# STOCKLAND DEVELOPMENT

## SUPPLEMENTARY REPORT ON TRANSPORT ASPECTS OF PROPOSED EXTENSIONS TO STOCKLAND SHOPPING CENTRE, GLENDALE

APRIL 2015

REF: 9154/3

# 8.8m MEDIUM RIGID VEHICLE SWEEP PATHS

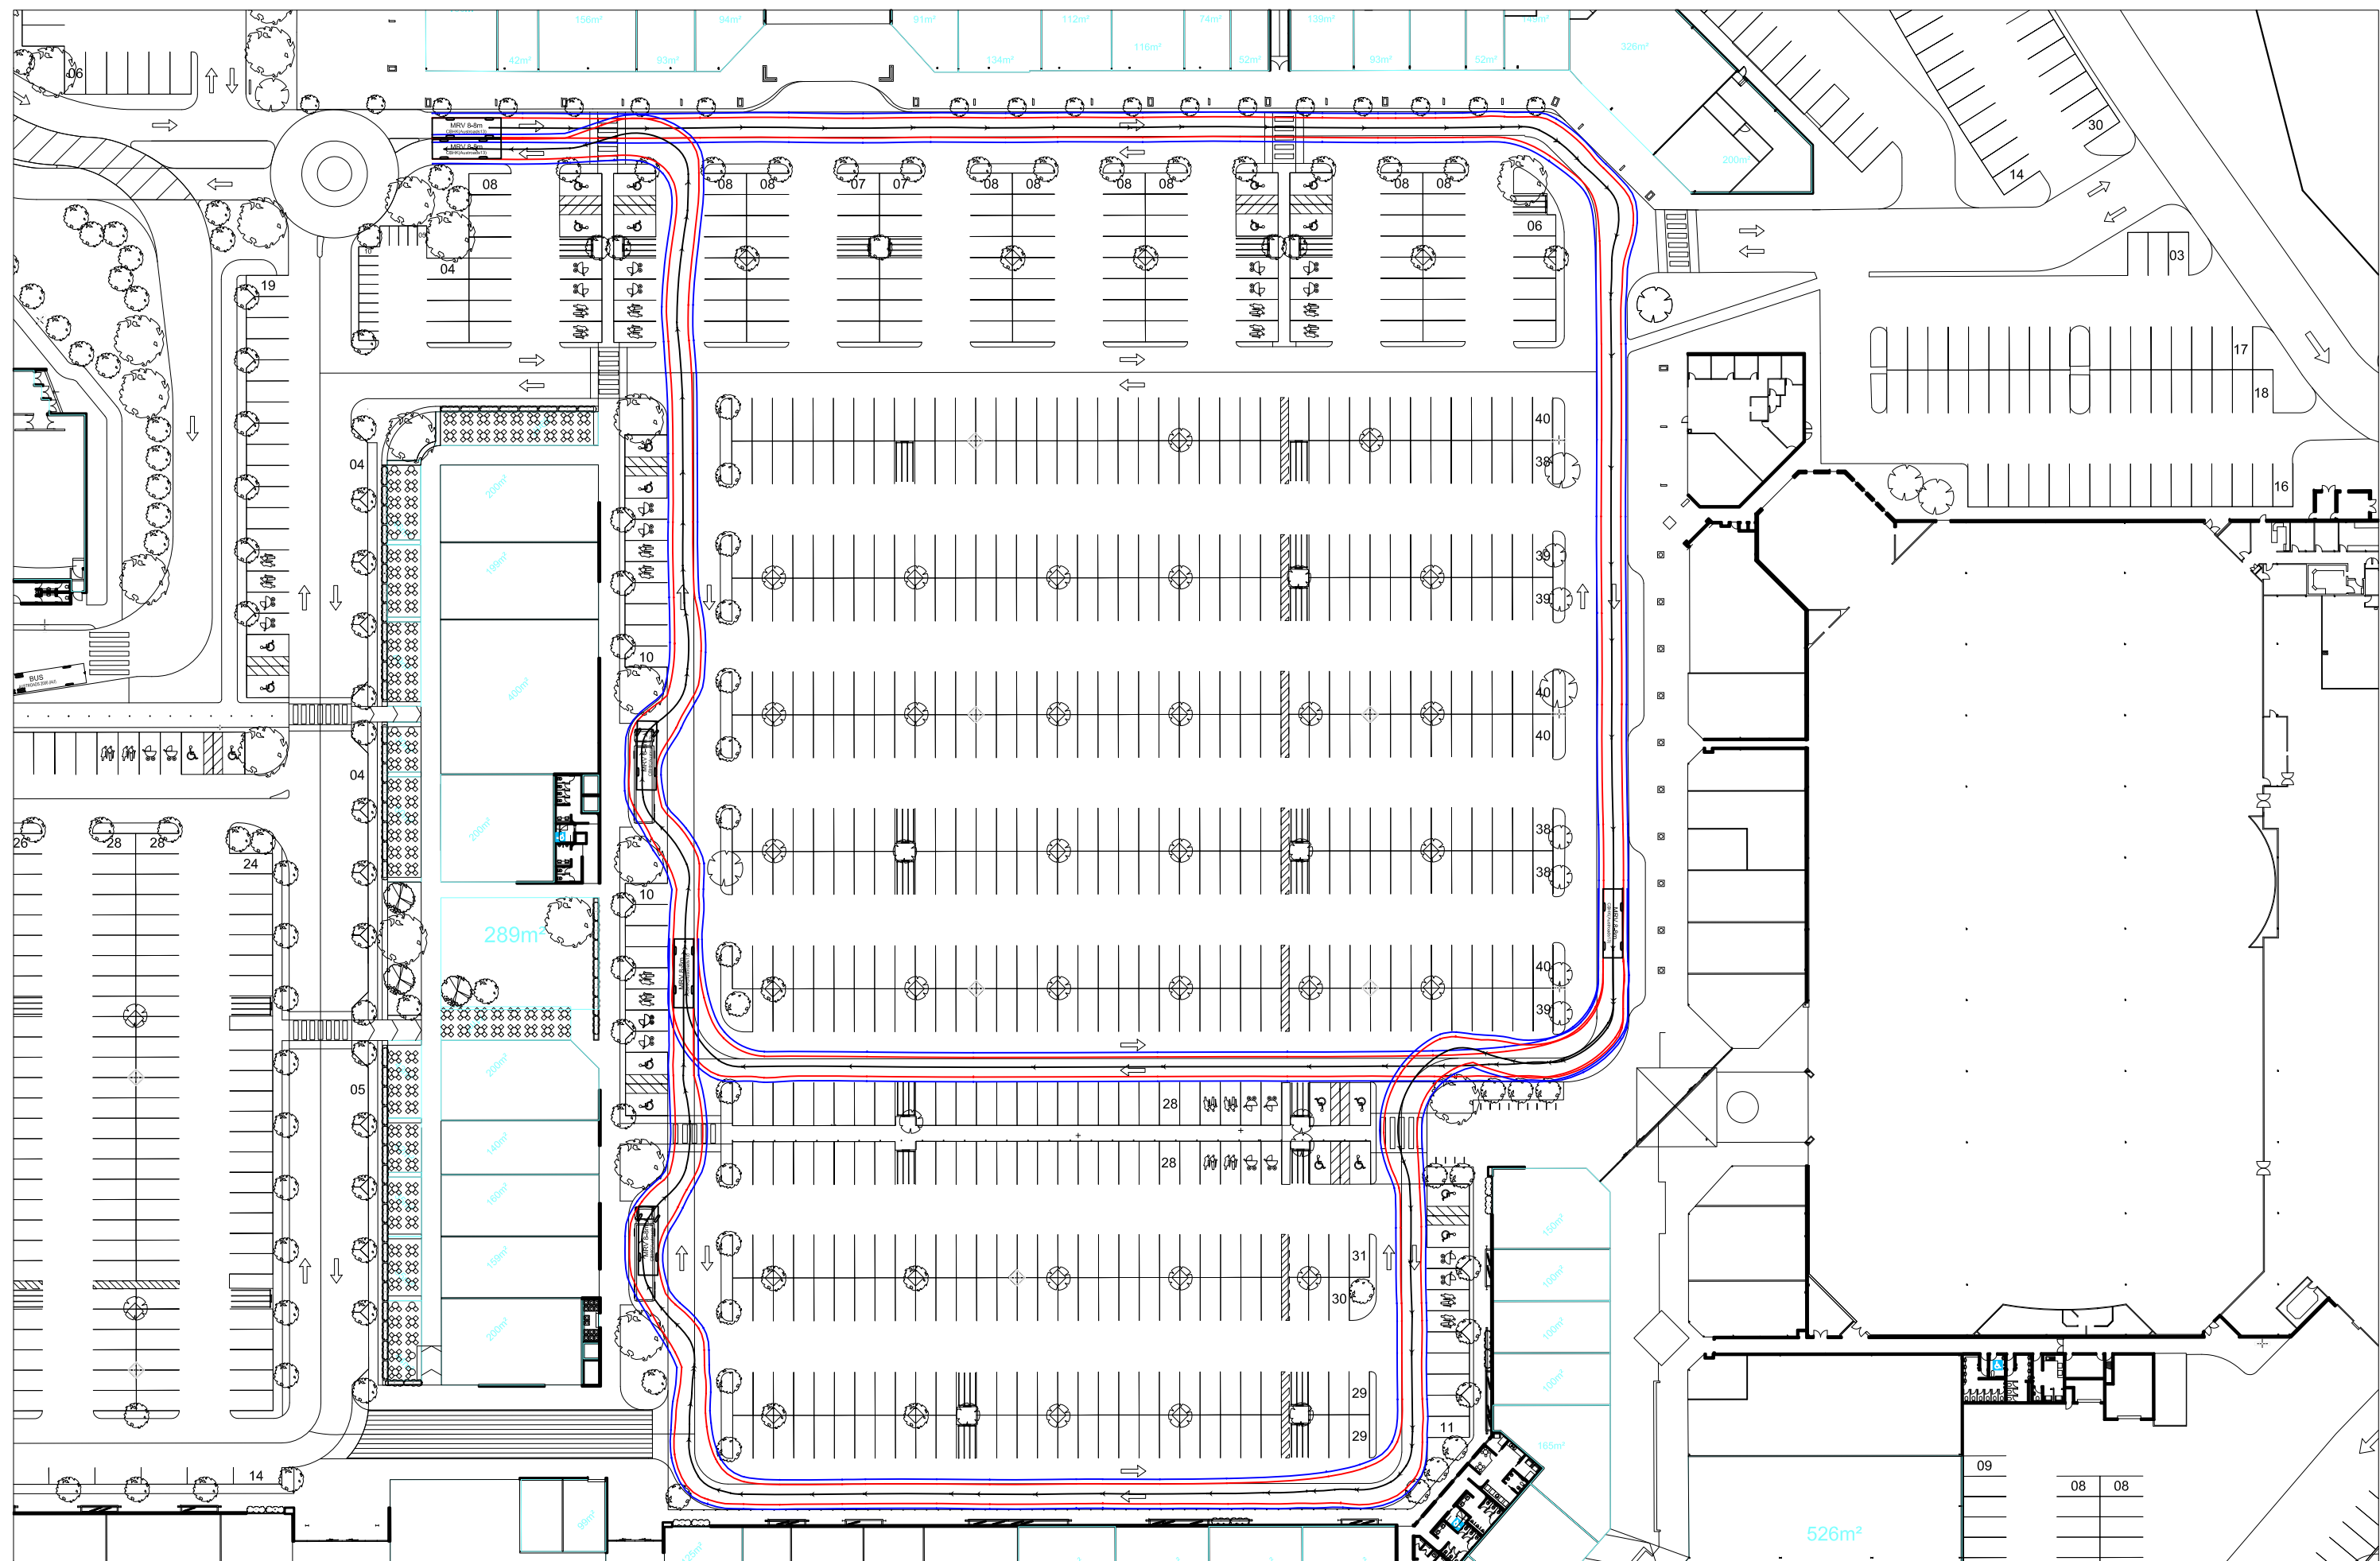
- the two new loading docks located on the southern side of the Casual Dining Precinct have been reconfigured to parallel bays to allow service vehicles (up to 8.8 metre long MRV's) to enter and depart the docks in a forward direction. Access to these docks would be limited to 8.8 metre long MRV's. Access to these docks is through the Target car park as shown in the truck turning paths attached to this report. Splitter islands within the car park have been removed.
